1997 - 1999 Corvette: Service Bulletin: SMU - Revised Seatback Cover Removal Procedure

Subject: SMU - Revised Seatback Cover Removal Procedure

Number: 99-08-50-002

Models: 1997-99 Chevrolet Corvette

Seatback Cover and Pad Replacement - Base Seat

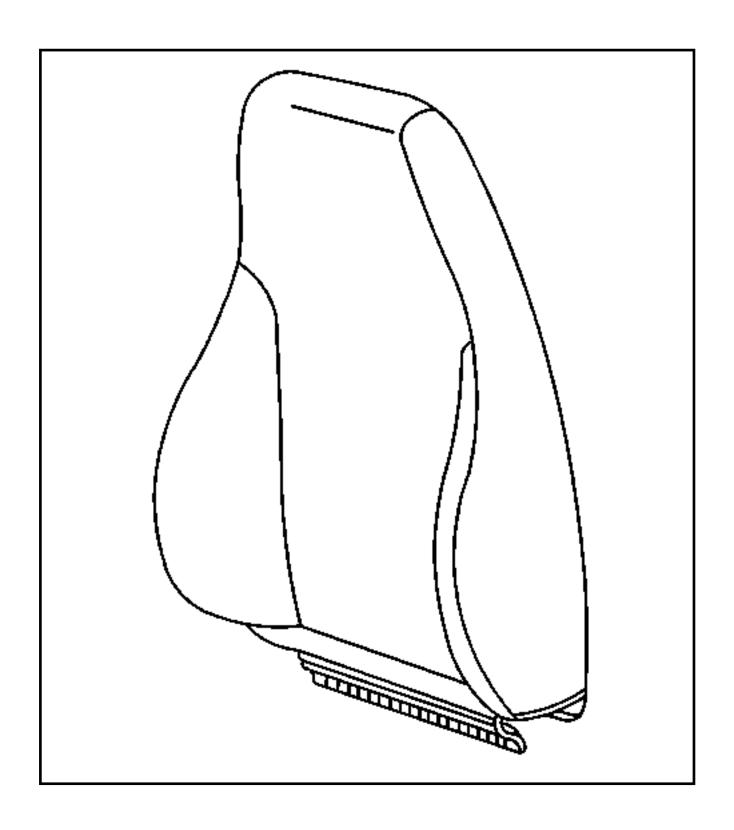
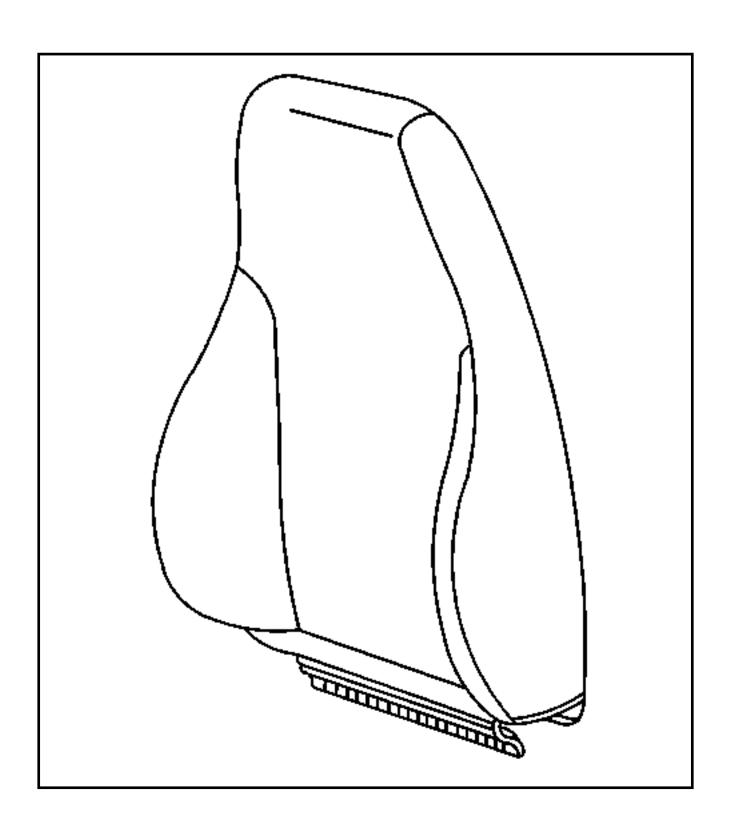
- 3. Unzip the seatback cover.
- 4. Unhook the seatback cover lower J strips by sliding the cover sideways.
- 5. Carefully slide and pull the cover material out from under the seatback release lever bezel.
- 6. Remove the cover unhooking the hook and loop fasteners from the foam pad.
- 7. Remove the upper fasteners attaching the foam pad (if removing the pad).
- 8. Remove the foam pad (if necessary).

- 1. Install the foam pad over the seatback frame (if removed).
- 2. Attach the foam pad top straps with fir tree fasteners (if removed).
- 3. Position the cover over the foam.
- 4. Carefully tuck the seatback material behind the release lever bezel.
- 5. Zip the cover closed.
- 6. Firmly pull the seatback cover down over the seat frame.
- 7. Hook the seatback lower trim cover J strip.

Seatback Cover and Pad Replacement - Sport Seat

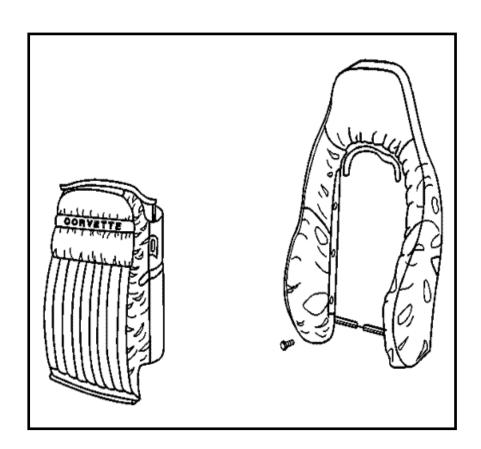
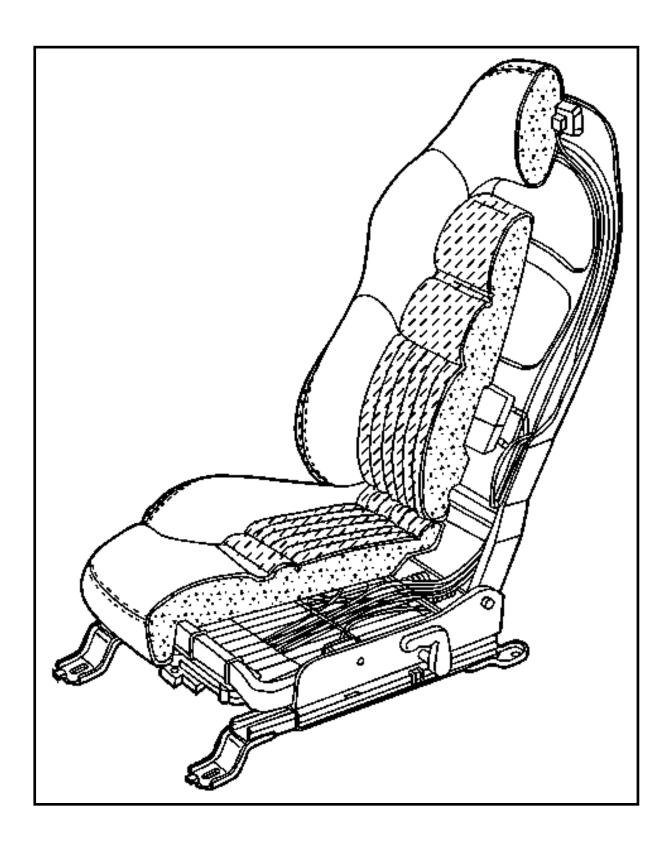
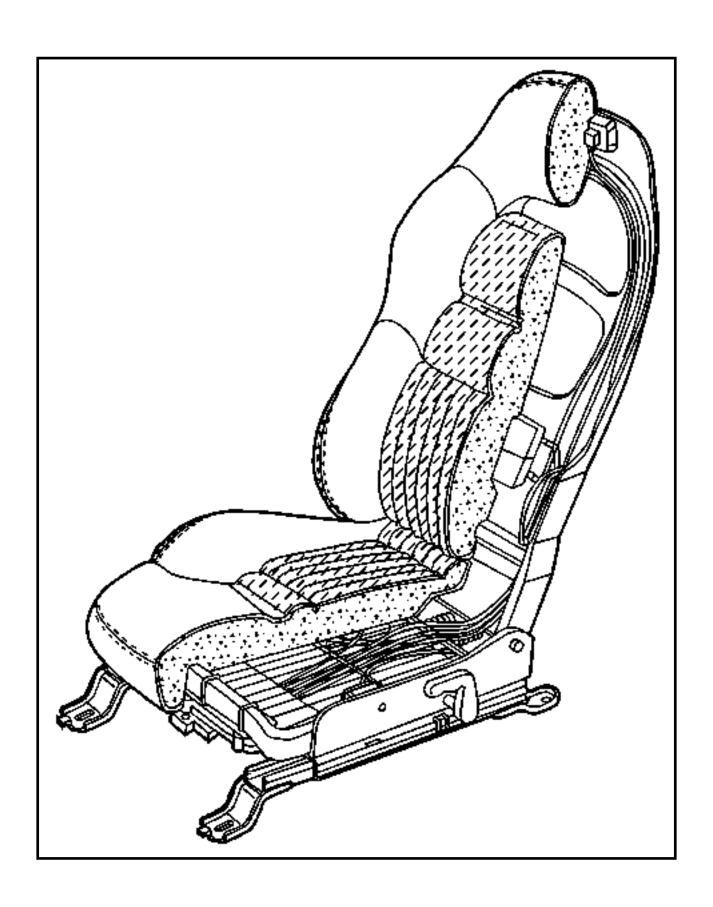
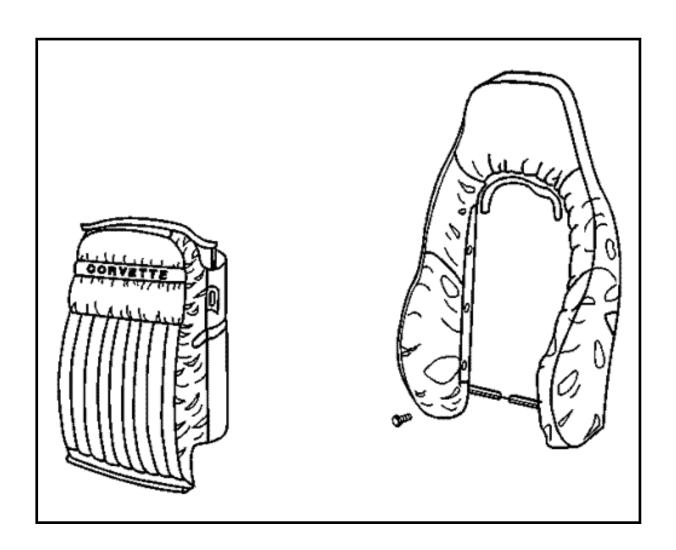
There are two size fir tree fasteners used. If the head of the fastener is 19 mm (0.75 in), it is possible to remove the trim by slightly raising the fir tree fasteners and then sliding the seatback cover tab over the head of the fastener. If the head of the fir tree fastener is 25 mm (1 in), it is necessary to remove the fastener.

- 2. Check the size of the fir tree fasteners heads.
- 3. Raise or remove the lower fir tree fasteners and detach the seatback cover from the seat frame.
- 4. Unzip the seatback cover upper zipper.
- 5. Carefully slide and pull the cover material out from under the seatback release lever bezel.
- 6. Pull the seatback cover from the bolsters.
- 7. Remove the fir tree fasteners from the foam pad upper retaining straps (if replacing the pad).
- 8. Remove the foam pad (if replacing the pad).

- 1. Install the foam pad (if removed).
- 2. Attach the foam pad top straps with fir tree fasteners (if removed).
- 3. Position the seatback cover over the seatback frame.
- 4. Pull firmly down on the seatback cover.
- 5. Attach the seatback cover with the fir tree fasteners using one of the following methods:
- Slide each of the seatback cover tabs over the 19 mm (0.75 in) head of a lower fir tree fastener and push the fastener in to secure.
- Install new fir tree fasteners through the seatback cover and the lumbar bladder assembly into the seatback frame.
- 1. Zip the upper zipper closed.
- 2.
- 3. Tuck the zipper ends out of sight into the seat trim.
- 4. Pull the back of the seatback cover down firmly.
- 5. Tuck the lower corners of the seatback cover over the foam.
- 6. Carefully tuck the seatback cover behind the release lever bezel.

7. Install the insert pillow. Refer to Seat Back Trim Replacement - Front (Sport Seat Insert Pillow).
